PLAN COMMISSION

Monday, October 19, 2020

AGENDA

5. BUSINESS.
 - a. Discussion and possible action on a site/design review application submitted by Rick & Susan Hubanks for an expansion of Angelo's Restaurant, 4706 Farwell Street.

WEST ELEVATION
1/8" = 1'-0"

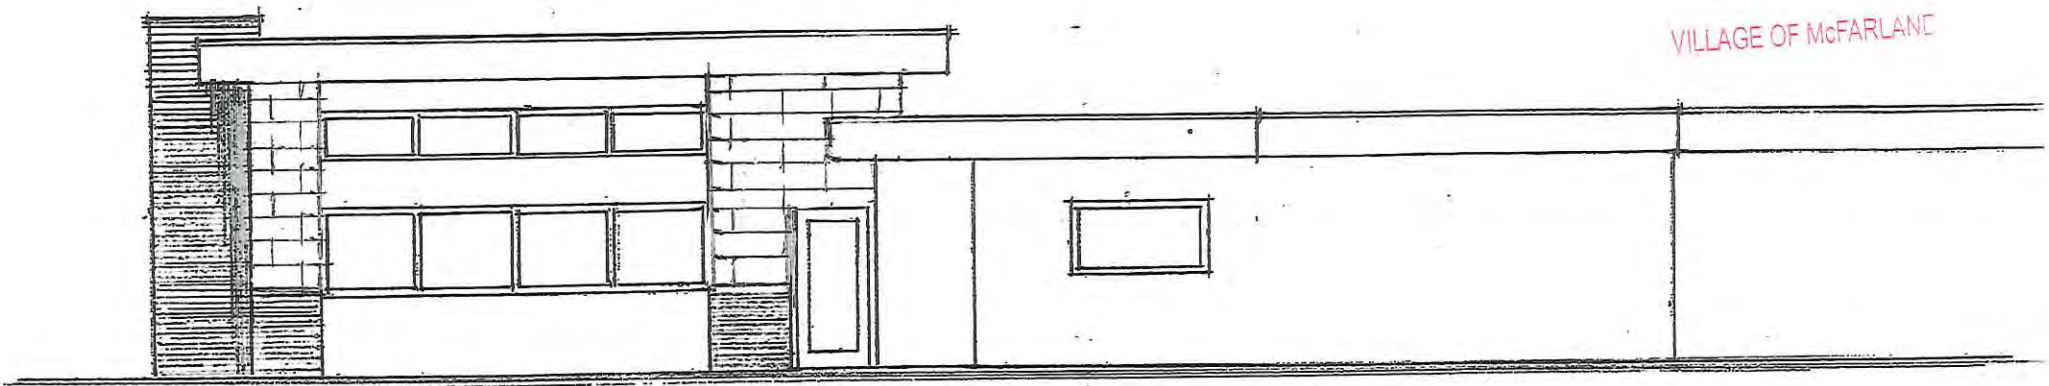
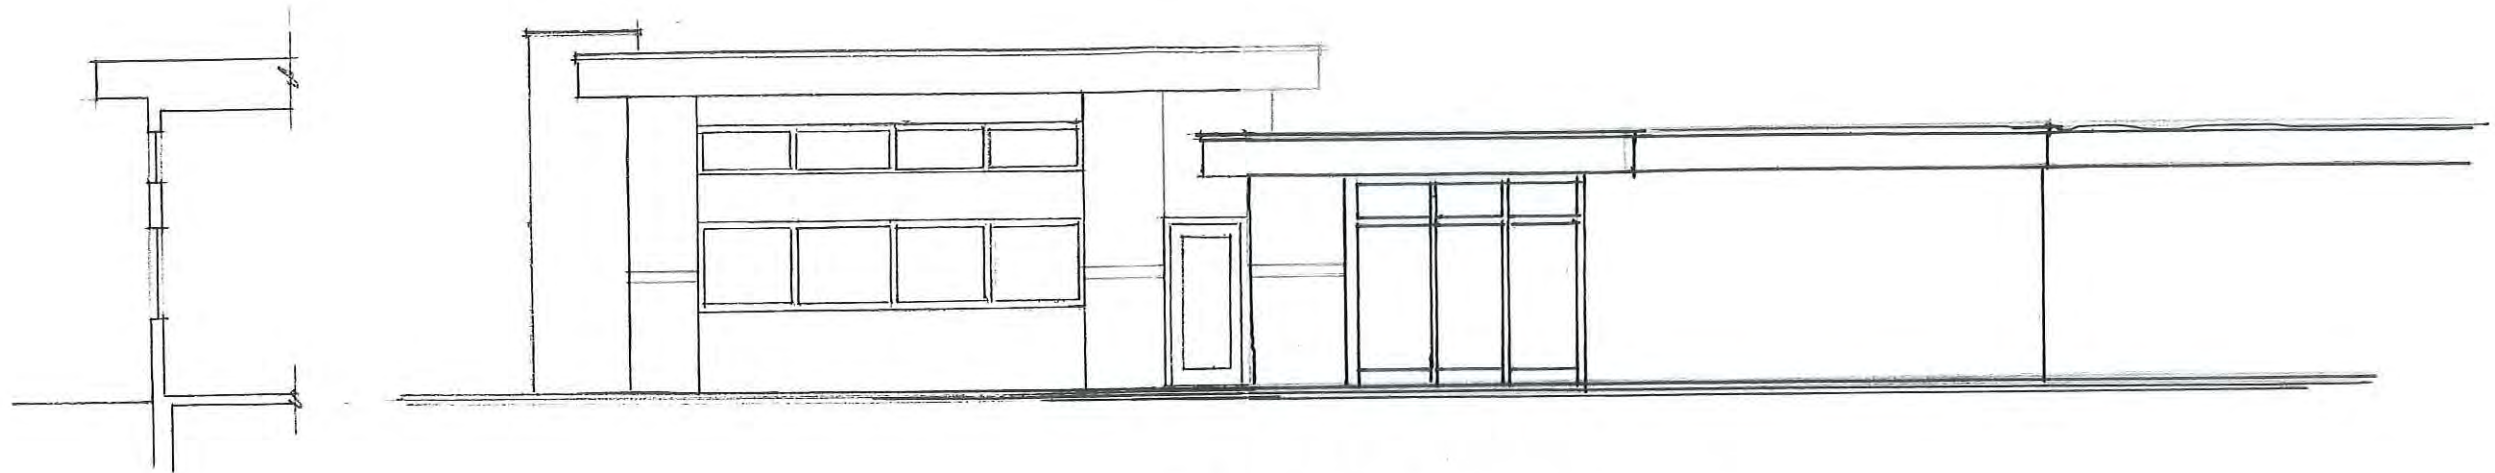
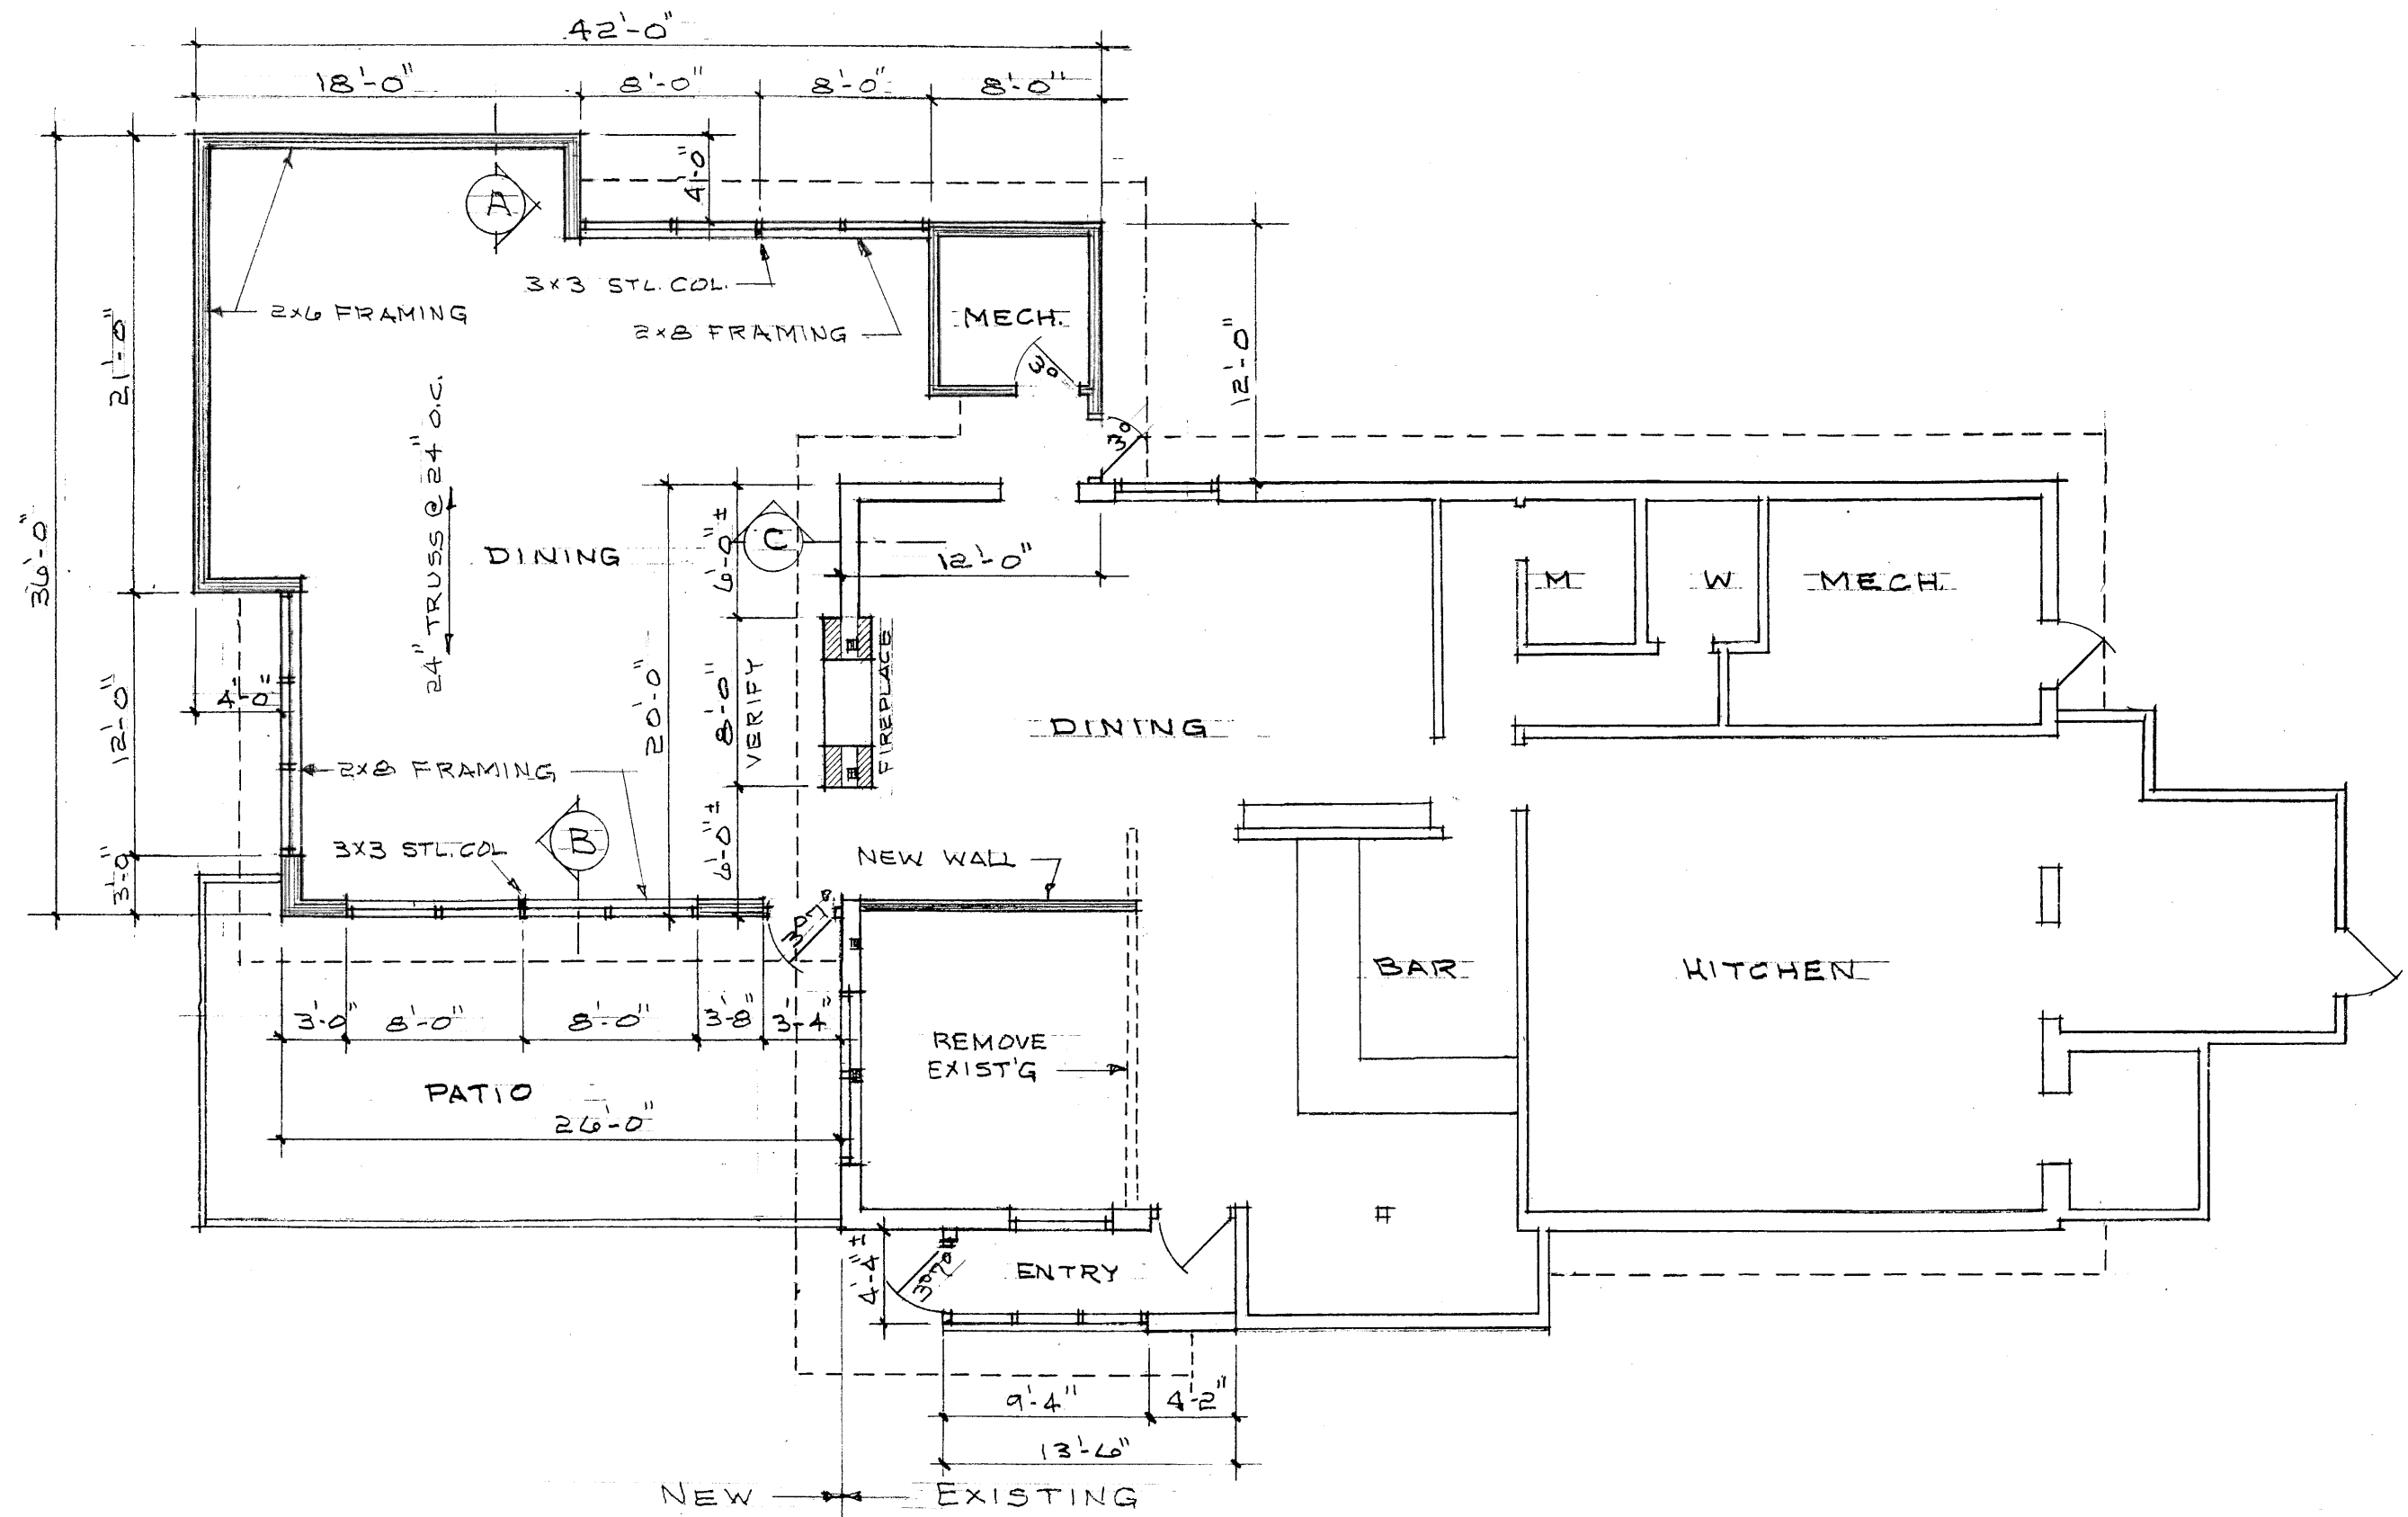
1. Addition of a second emergency exit on the east side of the proposed patio.
2. Providing either protective bollards, concrete planters, or concrete/masonry columns in the area of the fence in front of the two parking stalls.
3. Obtaining all necessary building permits related to the building addition, revised site signage, and new patio fencing.
4. Removal of the proposed ground mounted building accent lighting.

Applicant proposes using a vertical LED light bar on the southeast corner of the patio wall and ground mounted light fixtures on the west and south elevations of the proposed addition to accent the planned stonewood walls. The ground lights would be screened behind arborvitaes. In staff's opinion the ground lights may not be necessary given these two walls are planned for new LED backlight dimensional wall mounted letter signs.
